**RE: Mary River Project - Changes to Surveillance Network Program (SNP)  
Type 'A' Water Licence 2AM-MRY1325 - Amendment No. 1**

MARY RIVER PROJECT

MINE SITE  
WATER LICENCE MONITORING LOCATIONS  
POST CHANGE

FIGURE 3

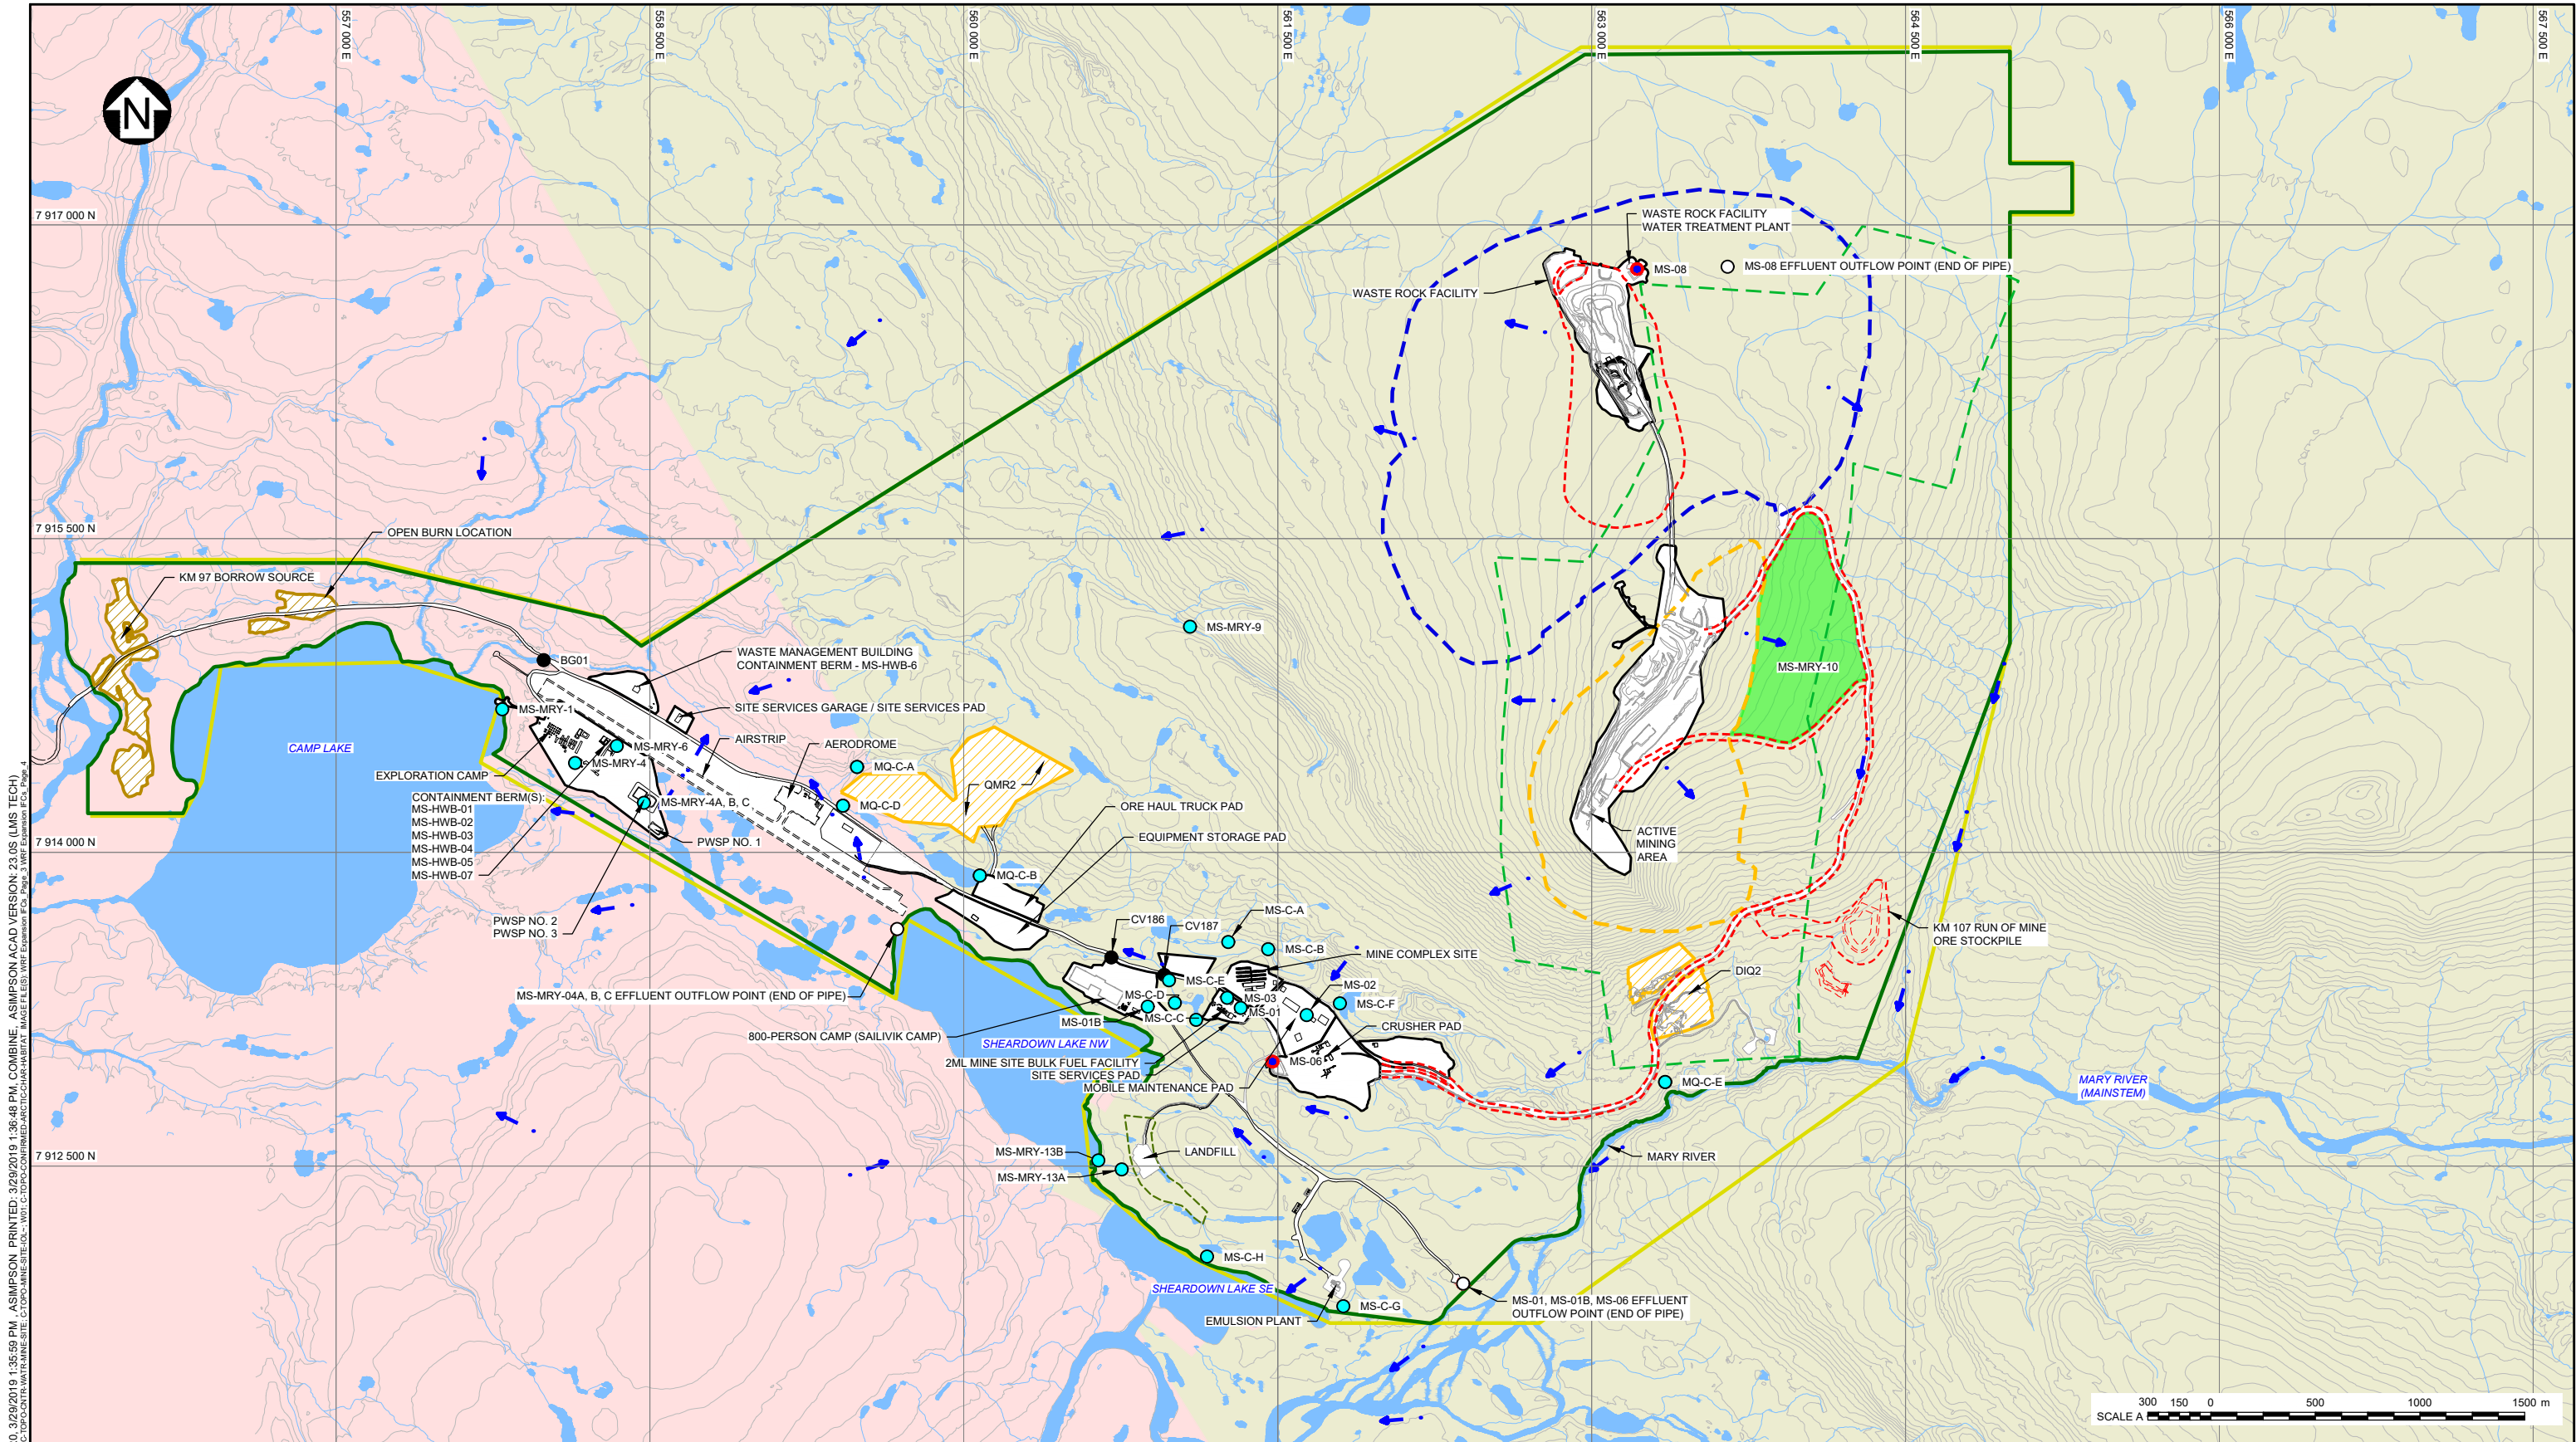
Proposed new locations for SNP stations MS-MRY-9 and 10 are presented in Figure 3. Coordinates for the new locations of MS-MRY-9 are provided in Table 2. The new locations/areas for MS-MRY-9 and MS-MRY 10 have been selected to provide sufficient coverage for the monitoring of surface water drainage downstream of active mining operations at Deposit No. 1.

During 2019, Baffinland will assess the MS-MRY-10 monitoring area identified in Figure 3 and determine a suitable location for MS-MRY-10. Factors that will be considered in identifying a suitable location for MS-MRY-10 will include safety, accessibility, the presence of reoccurring surface water flows and the source of flows.

| Monitoring Station        | MS-MRY-9            | MS-MRY-10               |
|---------------------------|---------------------|-------------------------|
| Coordinates (UTM; NAD 83) | 17 W 561080 7915078 | TBD (refer to Figure 3) |
